ADDENDUM No. 1

RFP No. 22-26

Street Resurfacing Project - 2022

SHEET No. 15 OF 61

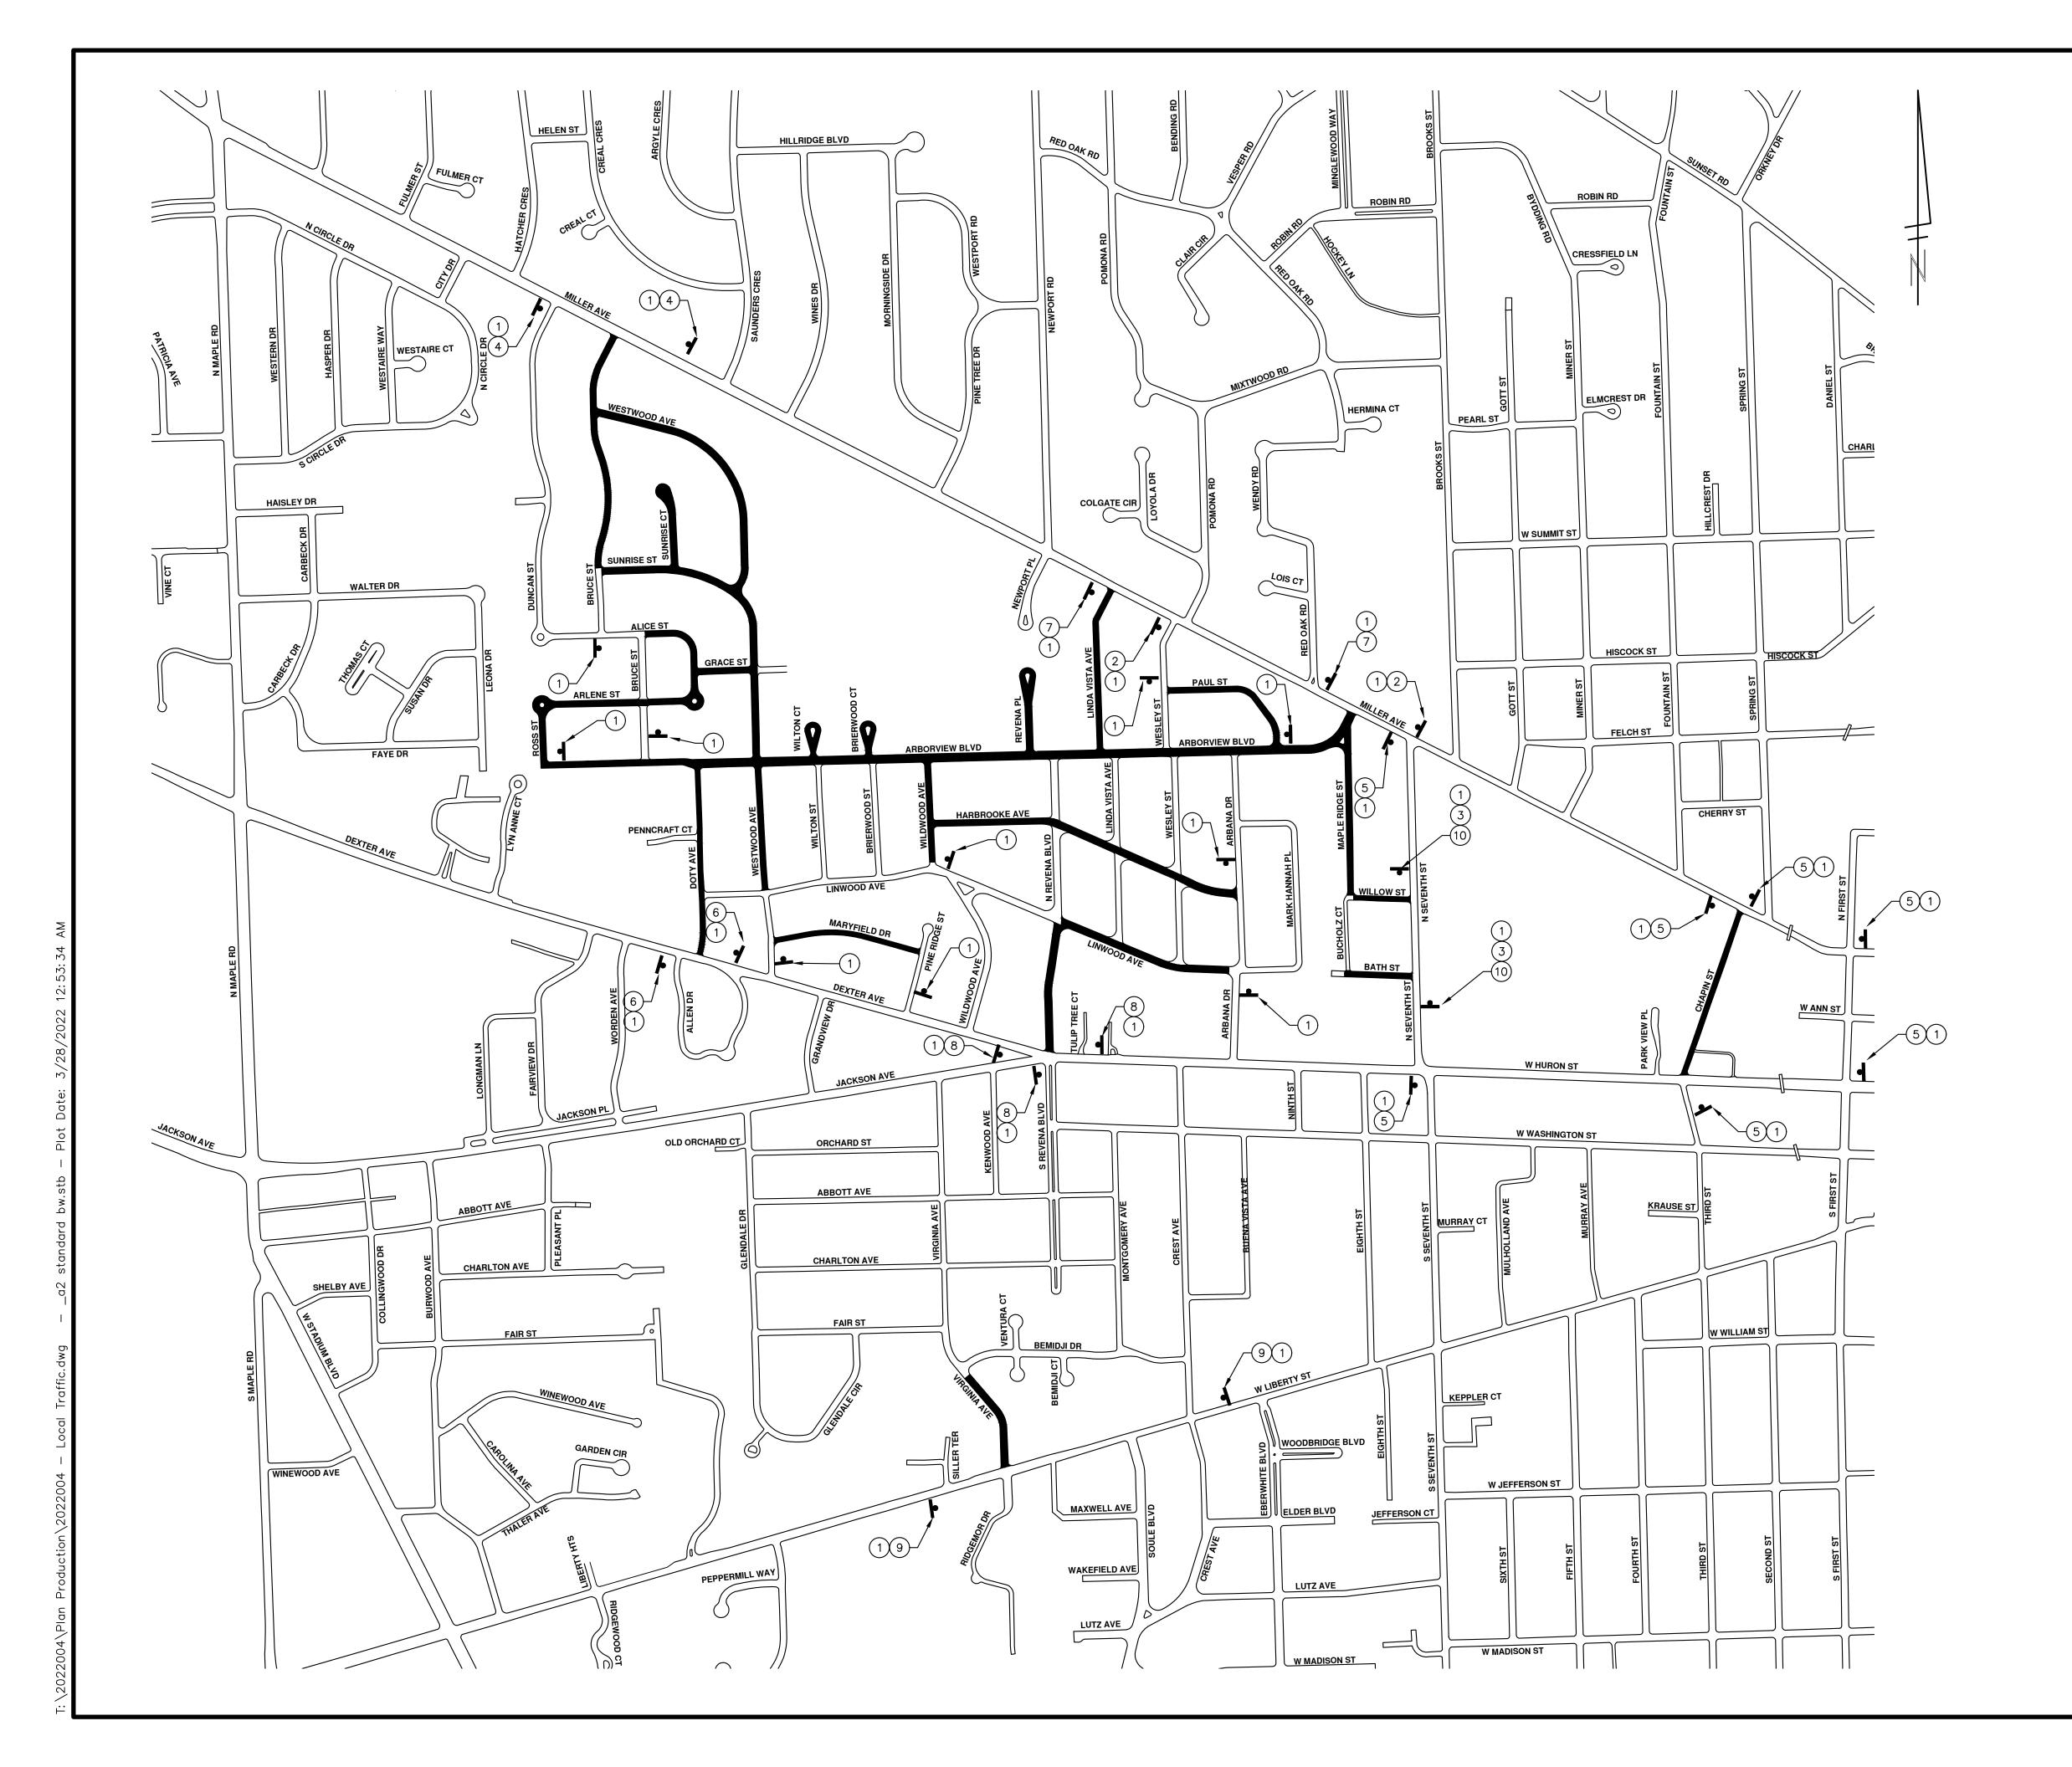
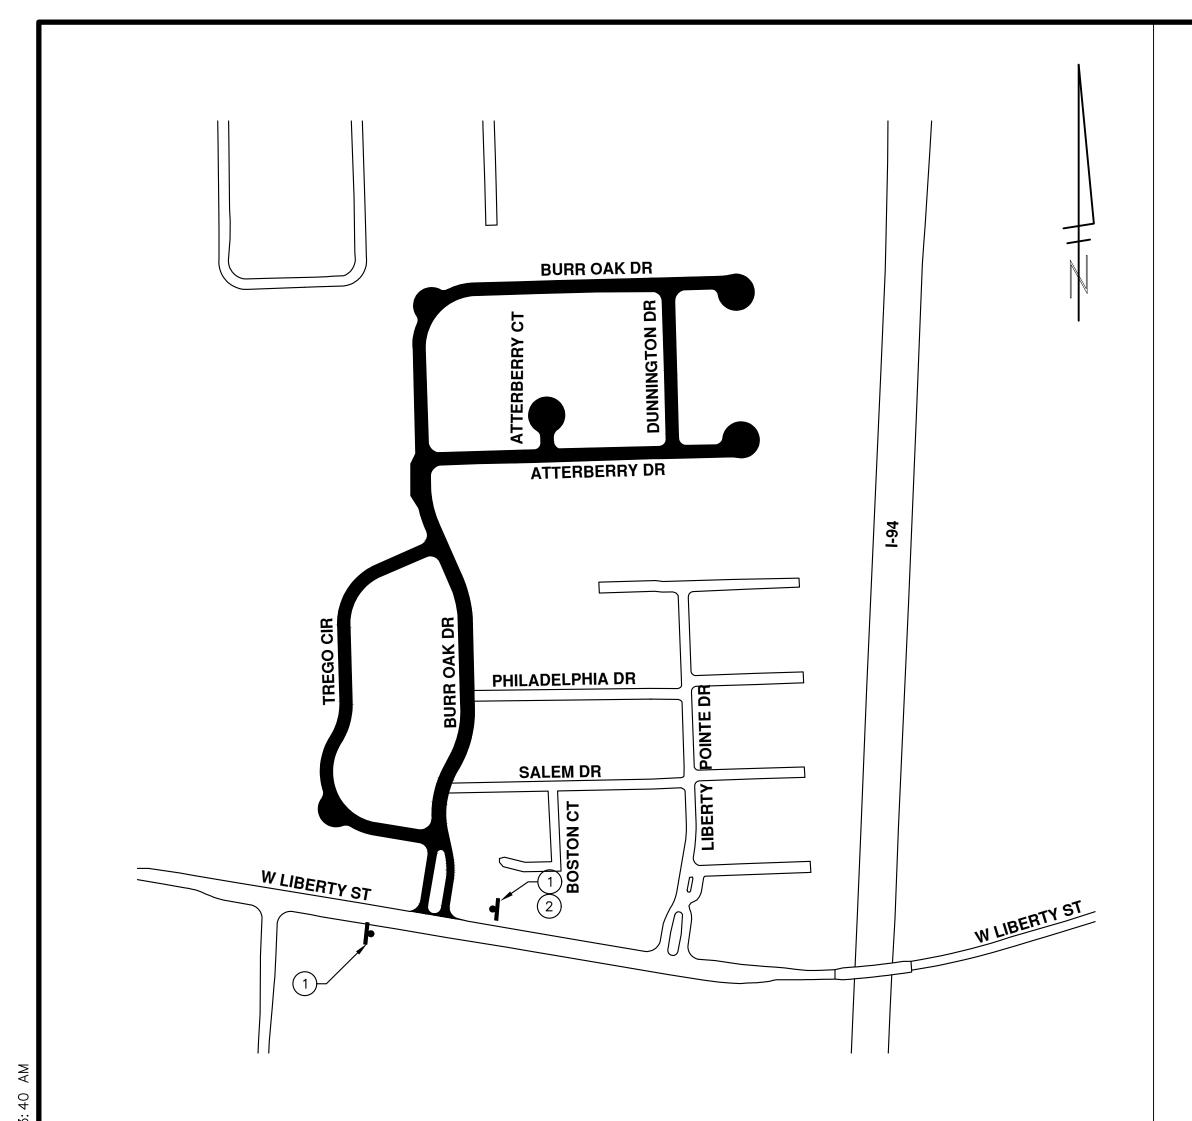
Removed unused signs, relabeled various signs and added Sheets 15-16

SHEET No. 59 OF 61

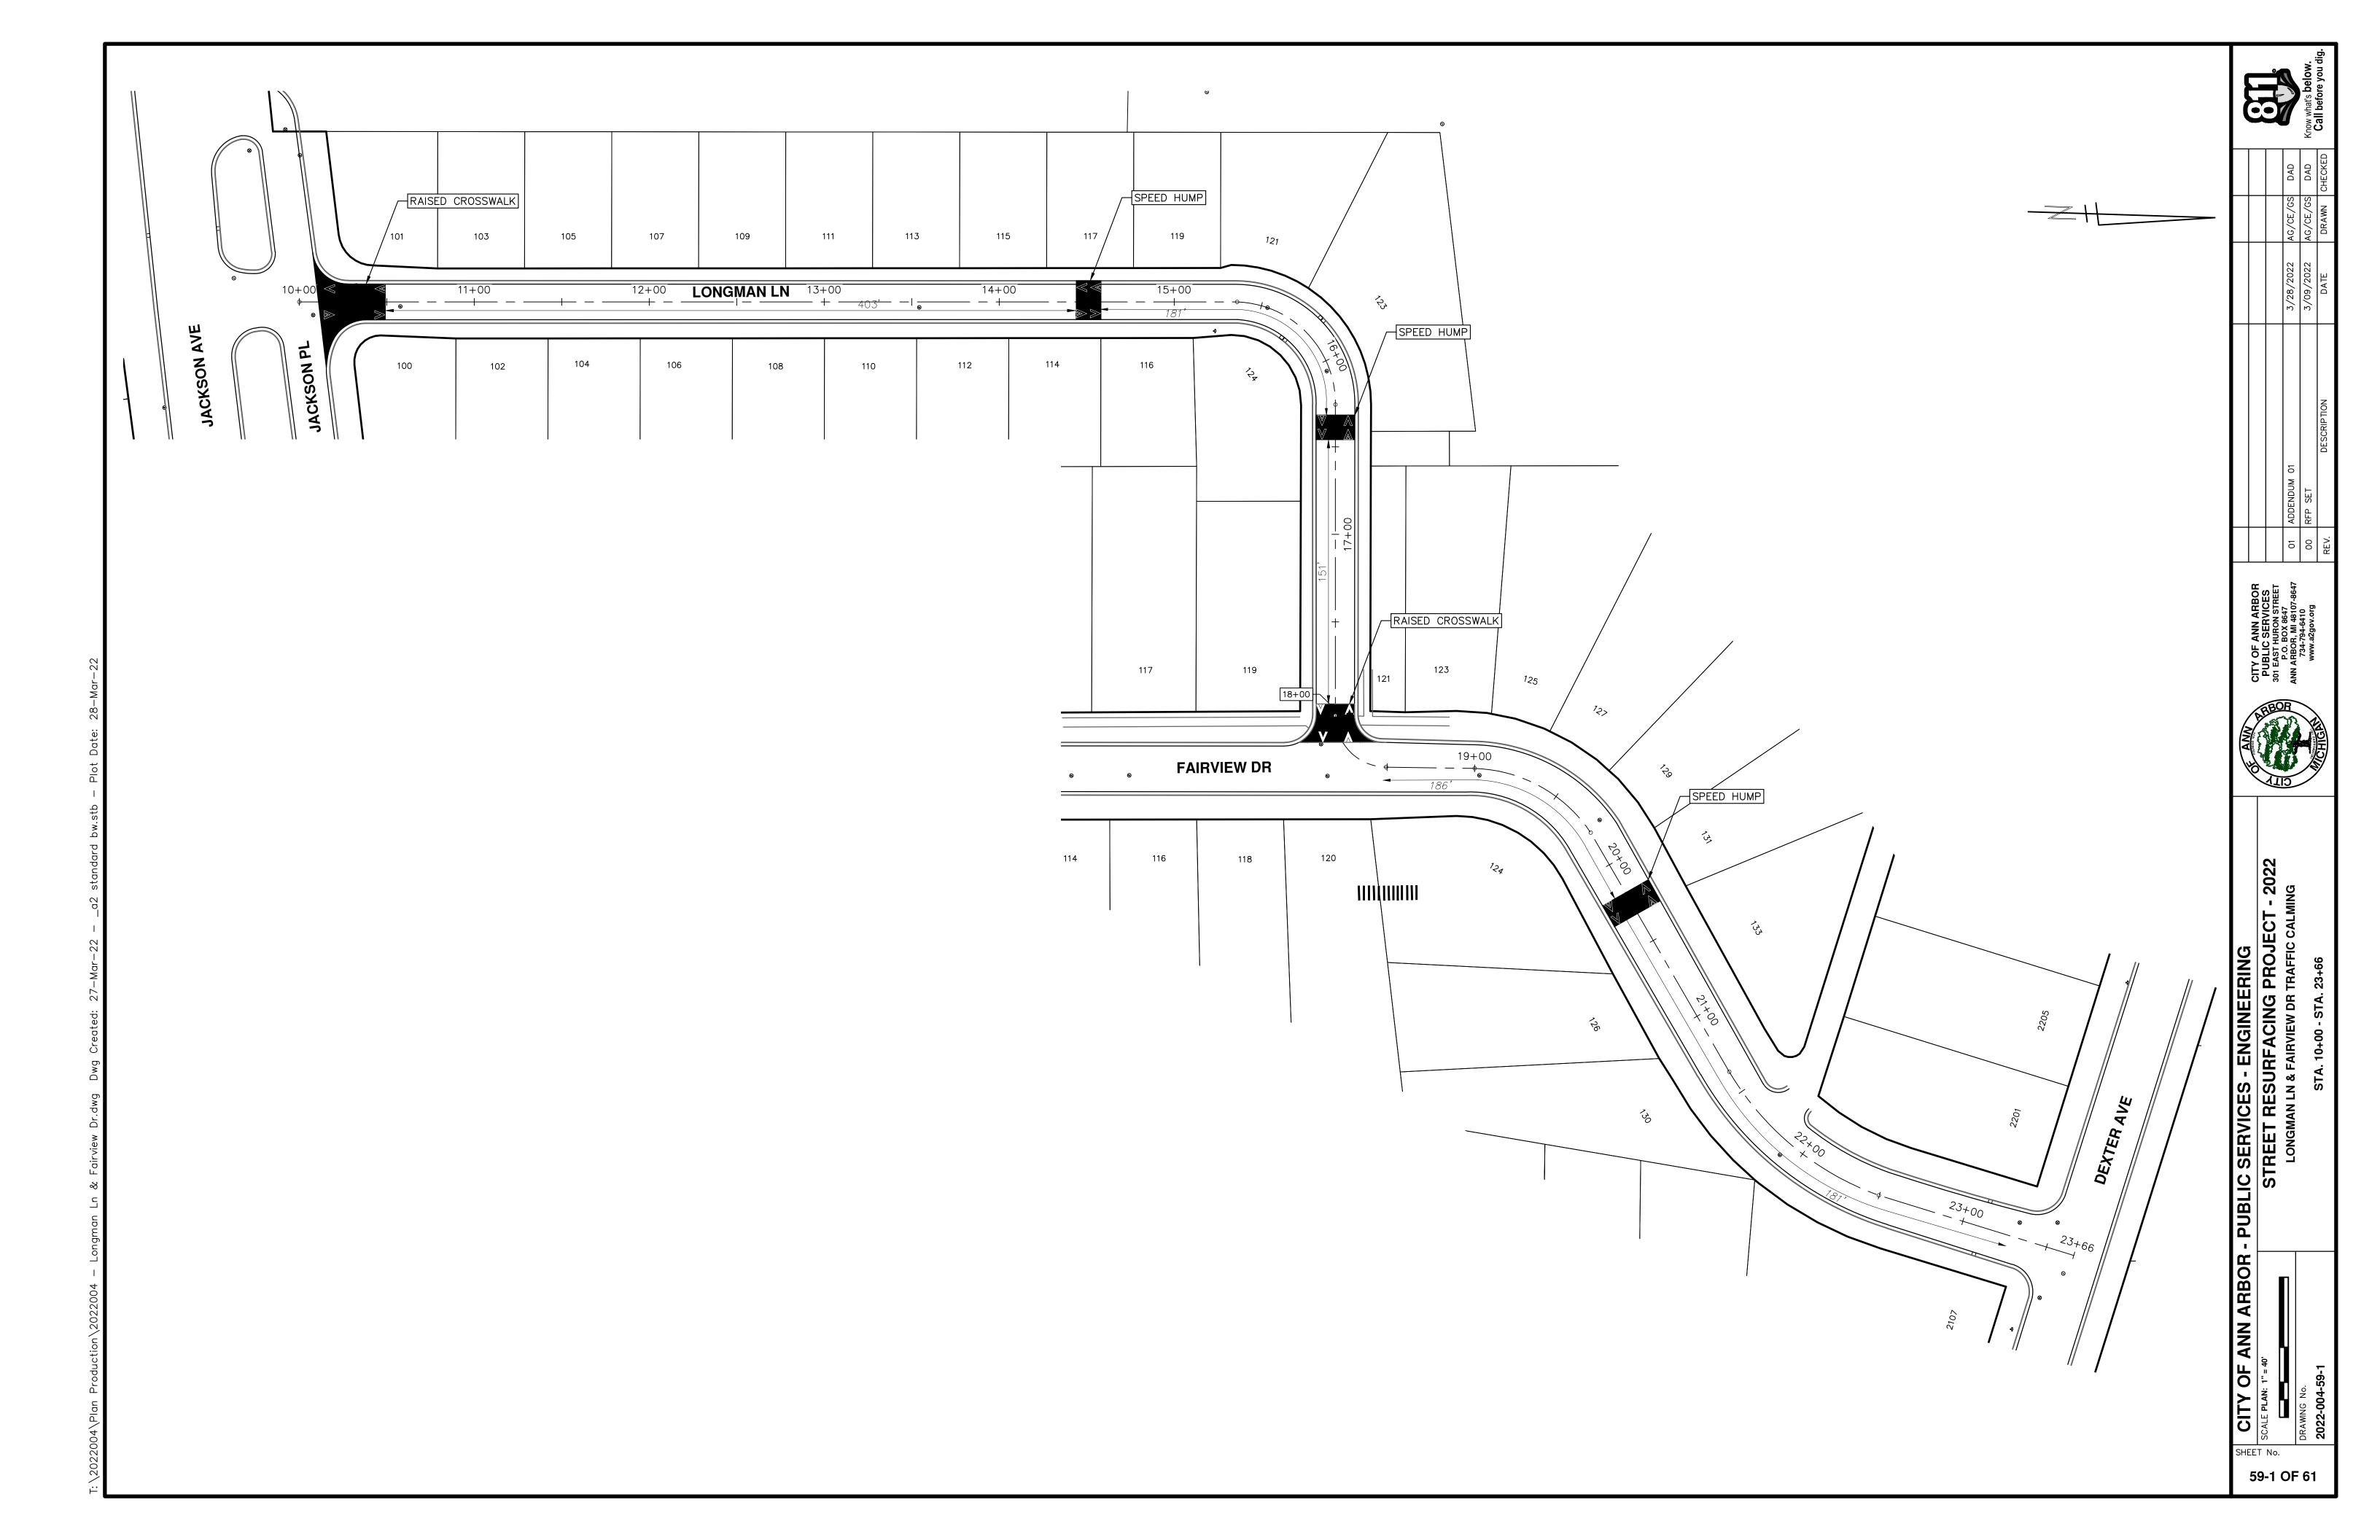
Sheets 59, 59-1, 60, 60-1, 61 New sheets added to plan set.
